ROCHESTER GAS AND ELECTRIC CORPORATION  
R.E. GINNA NUCLEAR POWER PLANT

Revision 13' to:

Quality Assurance Program For  
Station Operation

December 1987

FIGURE 2-1

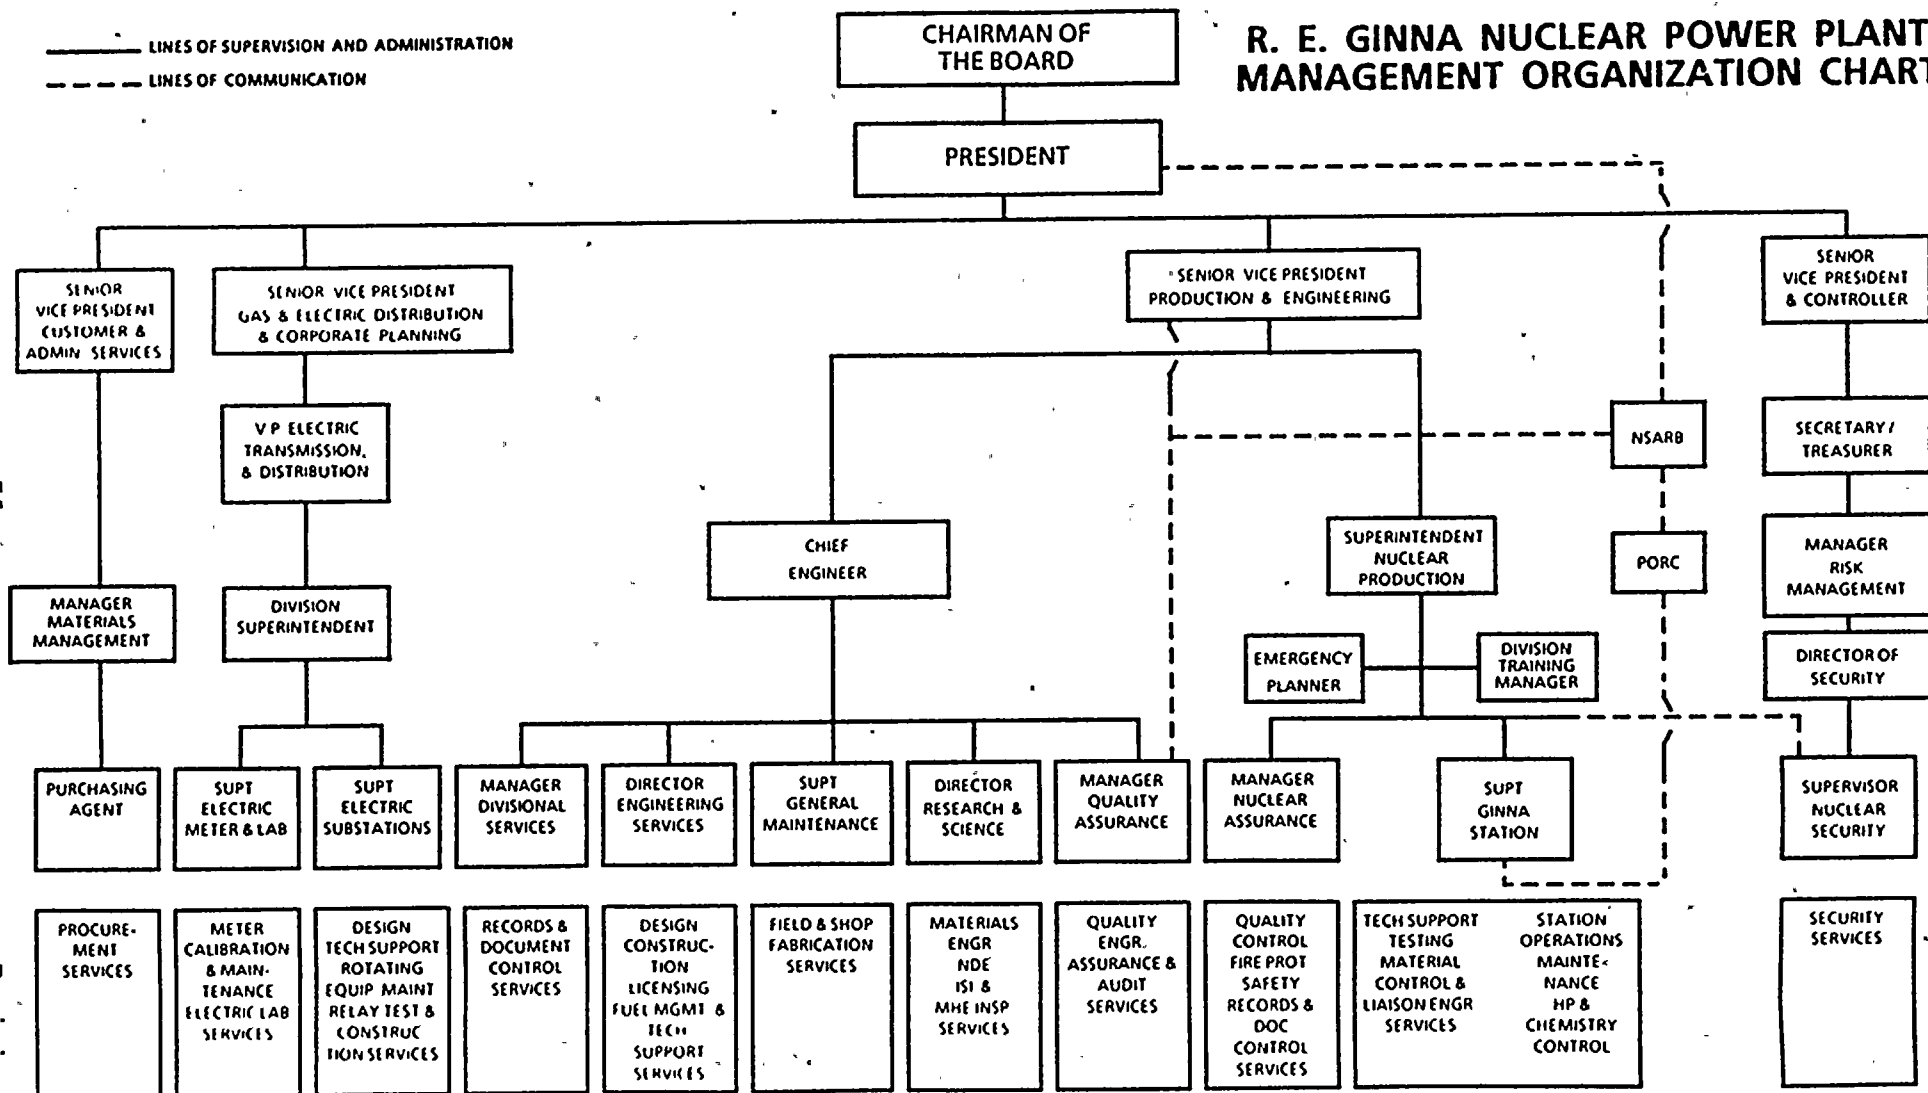
D | Revision 13 incorporates recent changes in the Management, Ginna, Electric Transmission and Distribution and Engineering organizations depicted in Figures 2-1, 2-3, 2-4 and 2-5 respectively. Additionally, clarifications have been made to sections 11, 16 and 17 and to Table 1 in response to the NRC comments contained in their endorsement letter of revision 12 dated February 27, 1987.
